## Keyless Feed Belt Pulley Upgrade

### Upgrade Application

Applicable to belted lead edge feeder

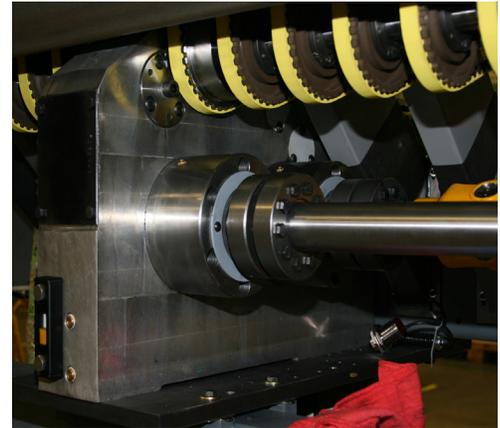
This upgrade replaces the existing plastic, keyed, timing pulleys with a new pulley designed to accept a locking element. This will eliminate the wear commonly seen with the keys. Also included is a new key-less shaft with a ringfeder center gear.

- Durable keyless pulley replaces nylon pulley
- Eliminate common key way wear by utilizing locking elements to affix pulleys to the drive shaft
- Maintains belt timing
- Increased board quality by reducing feed skew
- Reduces downtime associated with key wear
- Drop-in replacement kit includes the shaft, pulleys with locking elements, and center gear
- Very long life expectancy
